Village of Arlington Heights
Plan Commission
Board Room
Arlington Heights Village Hall
33 S. Arlington Heights Road
Arlington Heights, IL 60005
February 8, 2017
7:30 PM

File Number: PC #16-026
Project Title: Windsor Elementary School Addition
Address: 1315 East Miner Street
PIN: 03-29-412-015 thru -016, 03-29-412-042

WINDSOR ELEMENTARY SCHOOL ADDITION AND RENOVATIONS

Arlington Heights Fire Department Plan Review Sheet

Sheet No:
CSK-1

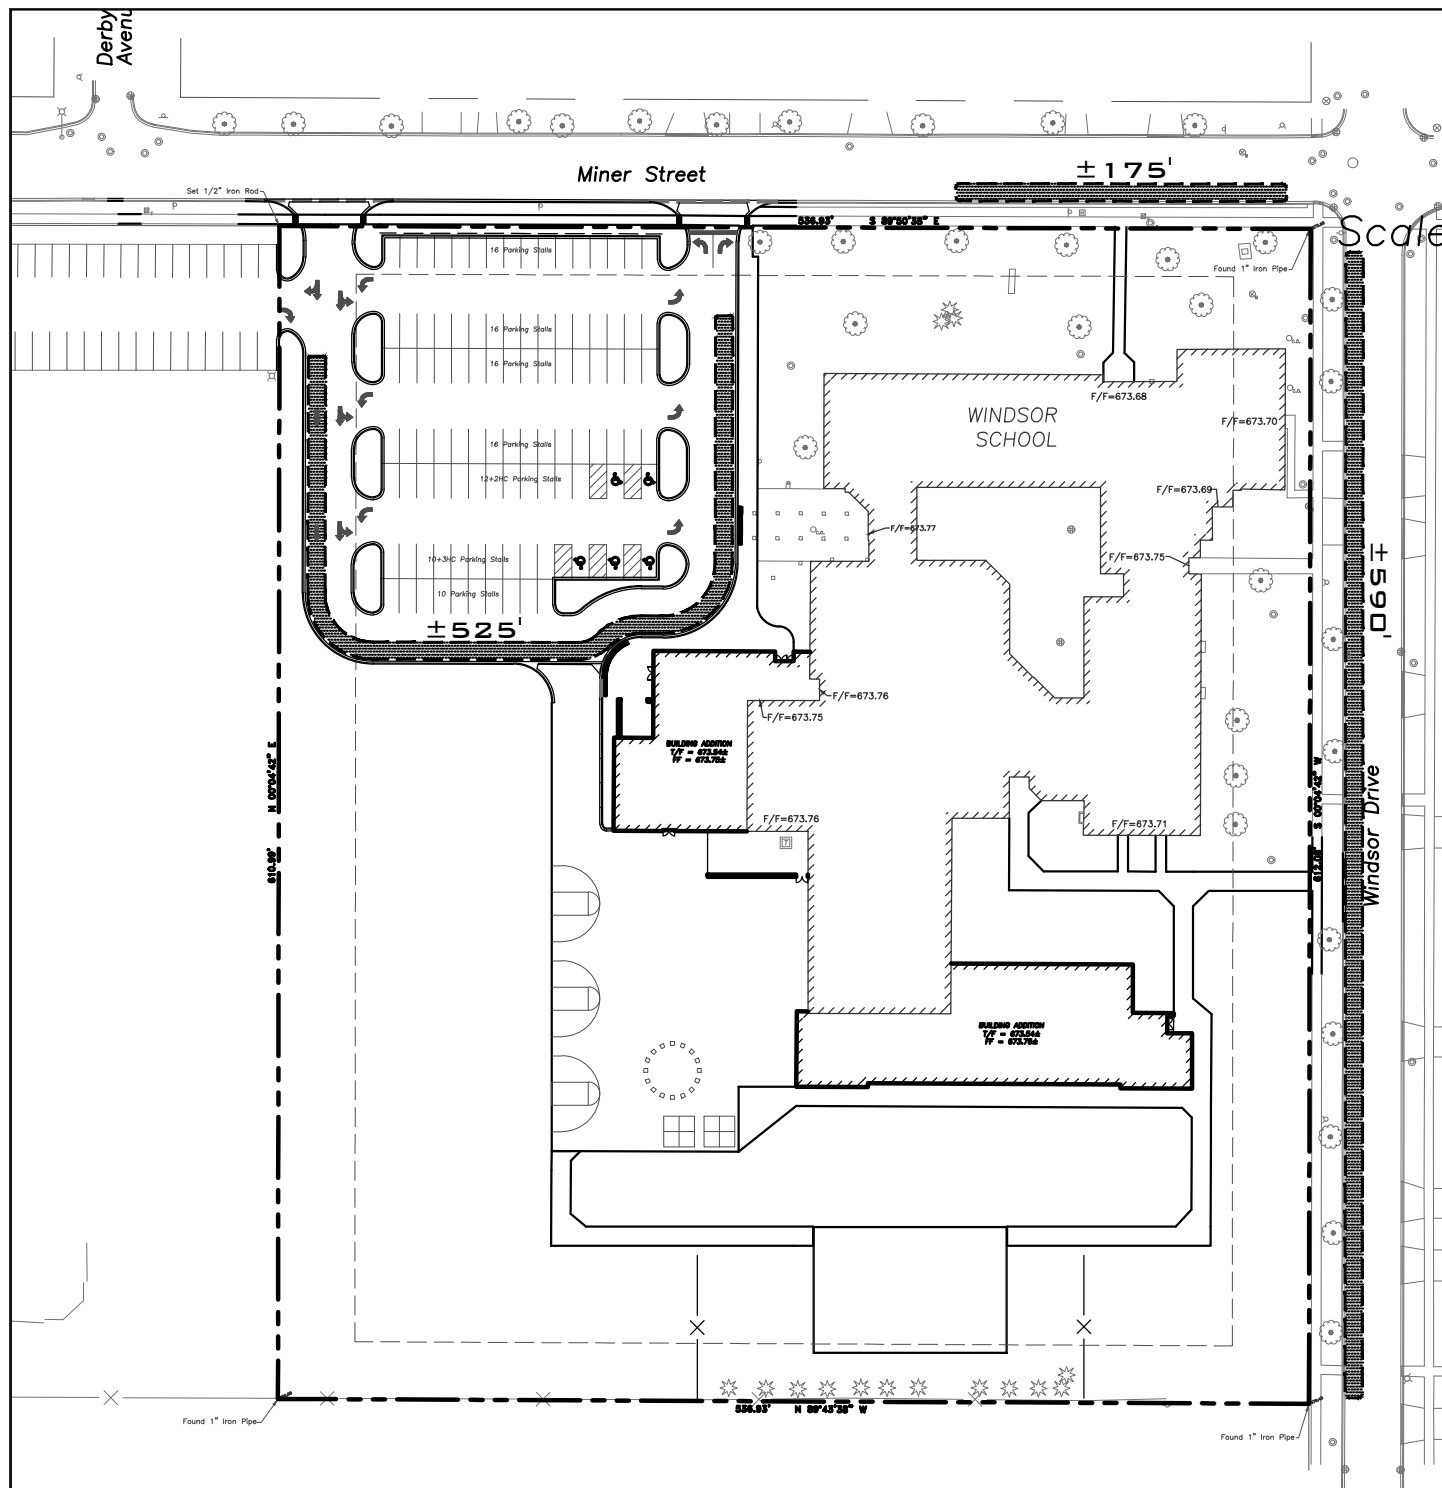
2. The School District shall convert the additional on-site landbanked parking into paved parking spaces as shown on sheet CSK-1 dated 1/25/17 prepared by Eriksson Engineering upon the request of the Village.

Sheet No:
C2.1

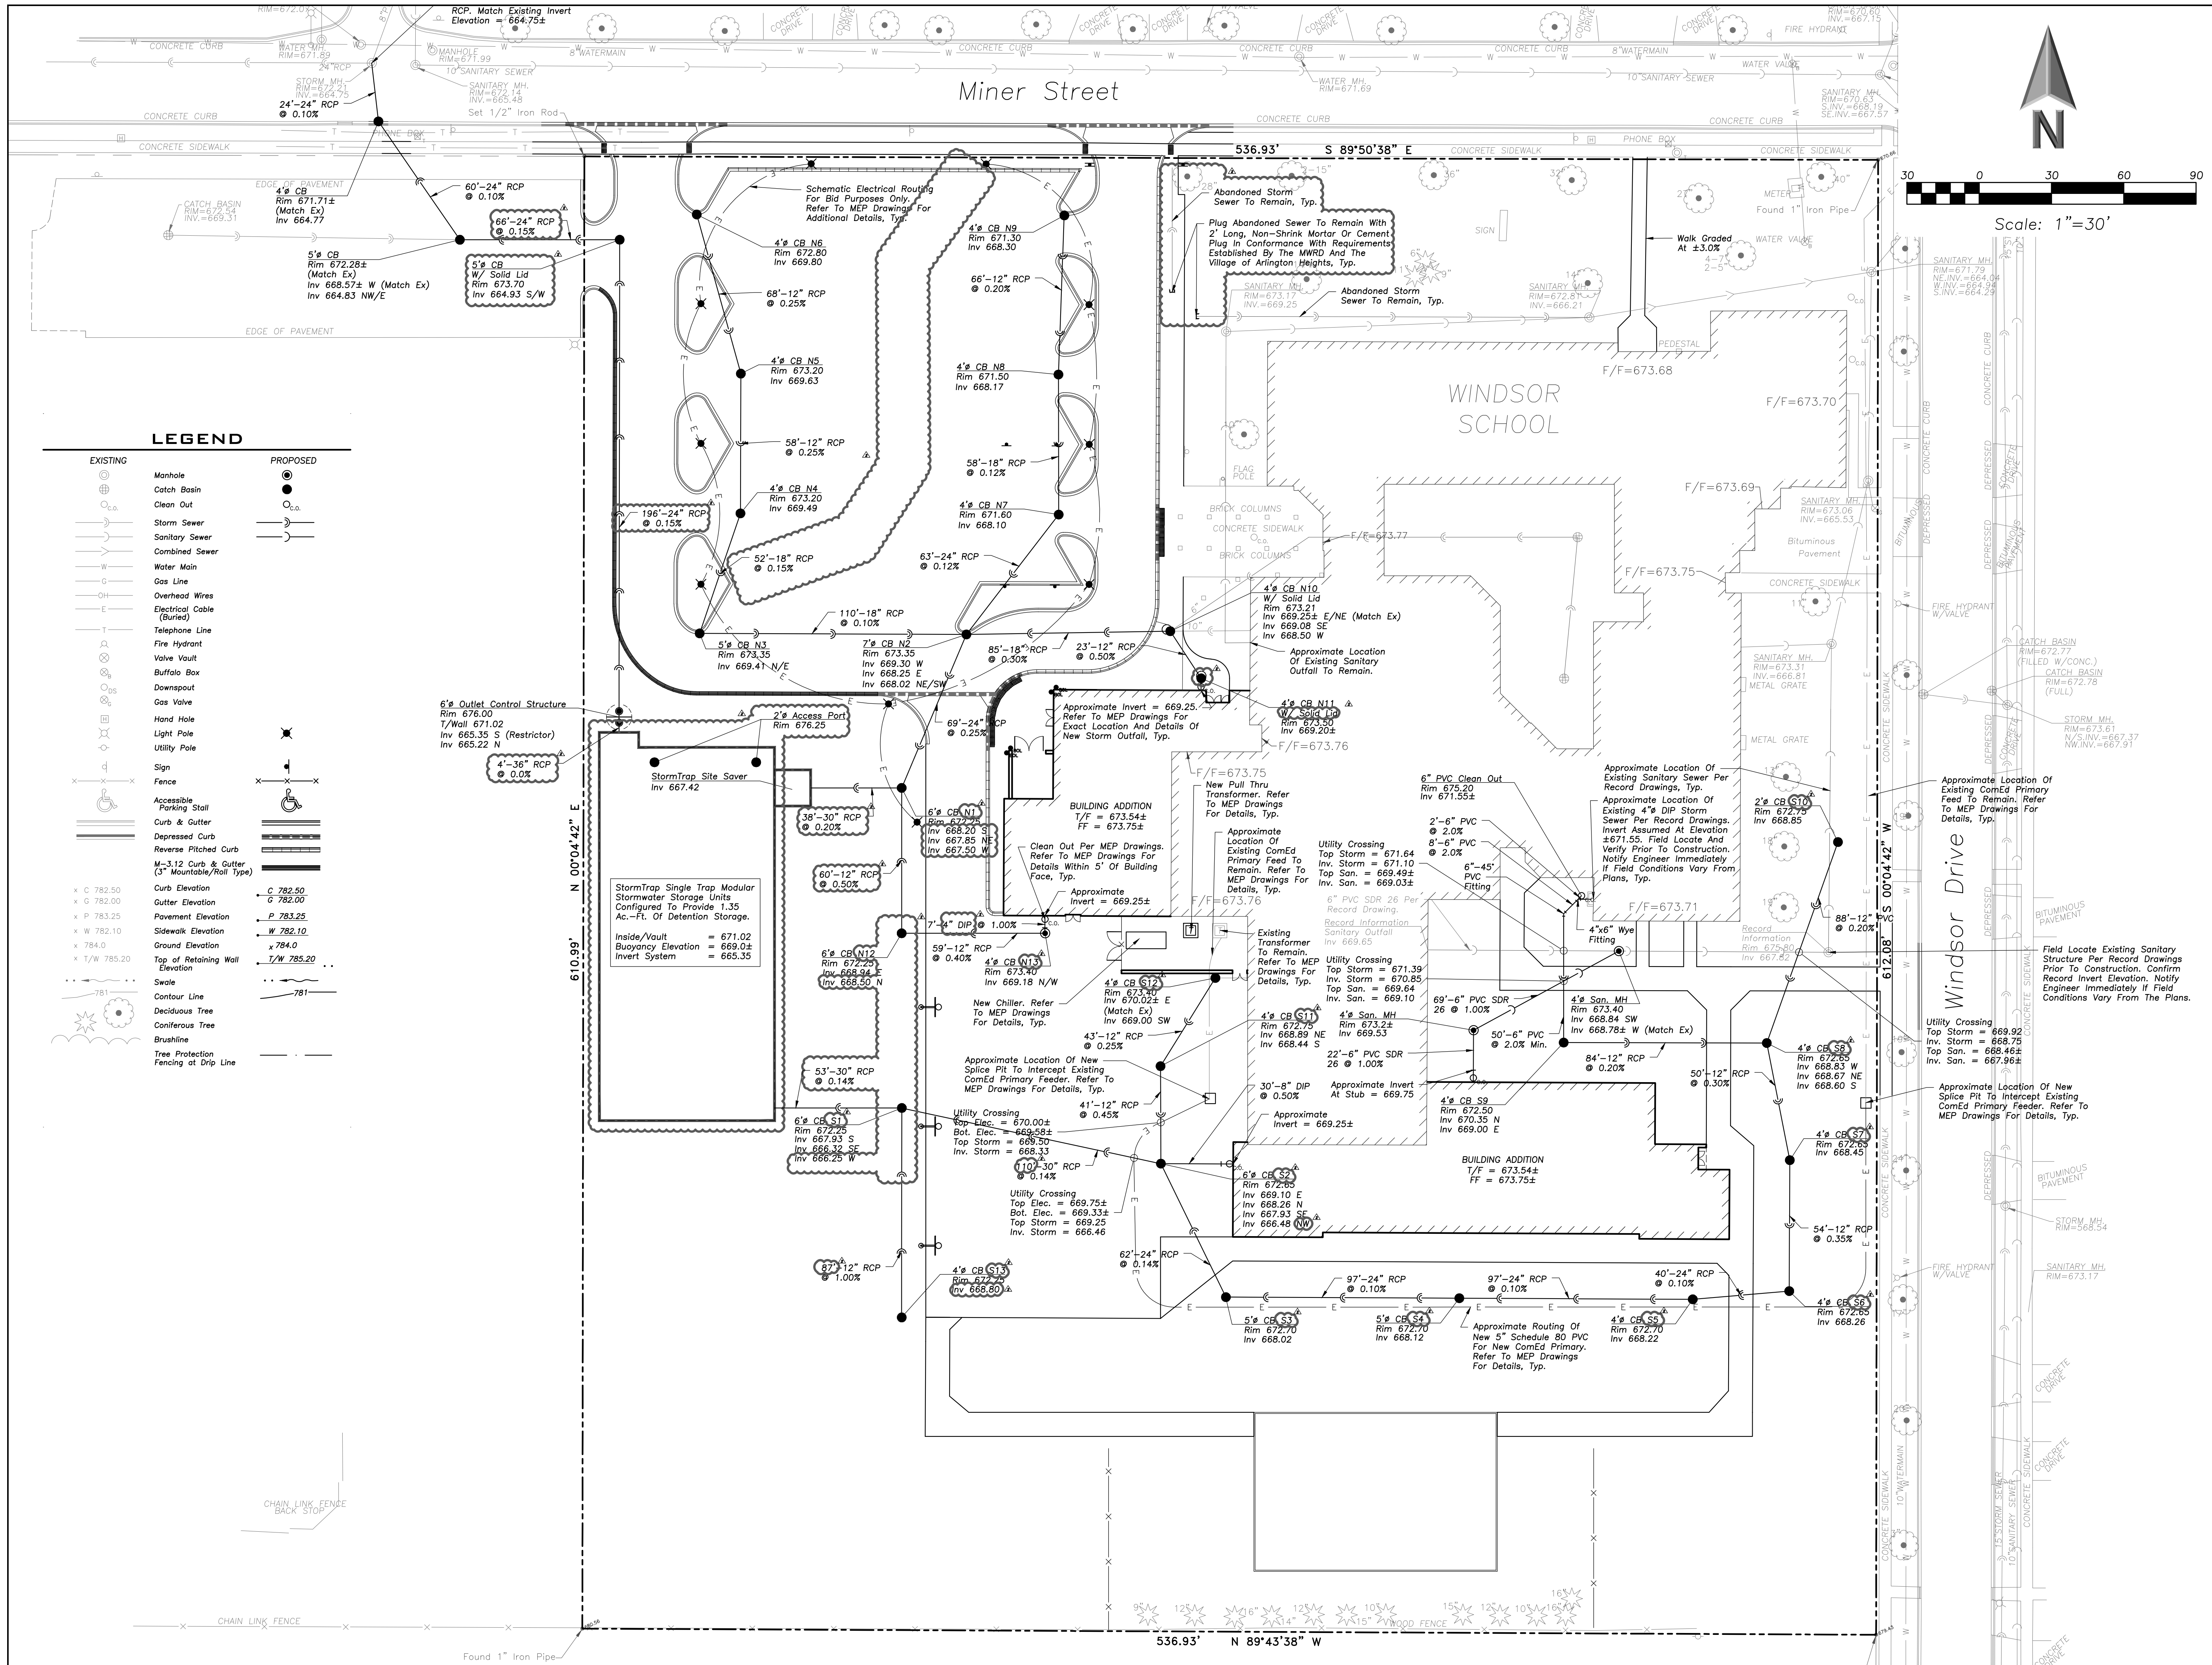
14. Please revise sheet C2.1 of the engineering plans to show the proposed setbacks of the building addition to the property lines.
15. Was the rubber surface play area considered as impervious surface and included within the impervious surface calculation?

24. In counting the total number of parking spaces as shown on sheet C2.1 of the engineering plans, it appears that only 90 parking spaces have been proposed, however, all documents submitted indicate that 92 parking spaces are proposed. Please clarify the total number of parking spaces proposed. One of the labels which totals the number of parking spaces in a parking row indicates 12 parking spaces and 1 handicap space will be provided, however, the row actually contains 10 parking spaces and 2 handicap spaces. Please revise this sheet to reflect the correct number of parking spaces. Additionally, the Traffic and Parking Study states that 92 spaces will be provided on the site; please revise this study to reflect that only 90 spaces will be added. Finally, please revise the Written Justification for Variation approval to reflect the correct number of parking spaces that will be included on the site.

25. Please revise sheet C2.1 to include “Do Not Enter” signage facing Miner Street at the “exit only” drive aisle where the drive aisle connects to Miner Street.

14. Please revise sheet C2.1 of the engineering plans to show the proposed setbacks of the building addition to the property lines.

24. In counting the total number of parking spaces as shown on sheet C2.1 of the engineering plans, it appears that only 90 parking spaces have been proposed, however, all documents submitted indicated that 92 parking spaces are proposed. Please clarify the total number of parking spaces proposed. One of the labels which total the number of parking spaces in a parking row indicates 12 parking spaces and 1 handicap will be provided, however, the row actually contains 10 parking spaces and 2 handicap spaces. Please revise this sheet to reflect the correct number of parking spaces. Additionally, the Traffic and Parking Study states that 92 spaces will be provided on the site; please revise this study to reflect that only 90 spaces will be added. Finally, please revise the Written Justification for Variation approval to reflect the correct number of parking spaces that will be included on the site.

25. Please revise sheet C2.1 to include "Do Not Enter" signage facing Miner Street at the "exit only" drive aisle where the drive aisle connects to Miner Street.

30. The responses to comments #7-#13, #15-#26, and #29 are acceptable.
31. The response to comment #14 is noted but does not address the comment. To reiterate, the comment asked to show on sheet C2.1 **the proposed setback of the building addition to the property lines**. The revision to the plans only showed the required building setbacks. In other words, please indicate how far the southern classroom addition will be located from the east and south property lines, and how far the gym addition will be located from the north and west property lines.

1. Prior to Village Board consideration, the petitioner shall address the following:
 - a. The petitioner shall revise the engineering, landscape, and other necessary plans to reflect the revised parking lot layout as shown on sheet C2.1 and dated as revised on 1/24/17, which plans are subject to review by the Village and must be in conformance with all applicable village regulations

The proposed building setbacks have been added to Sheet C2.1.
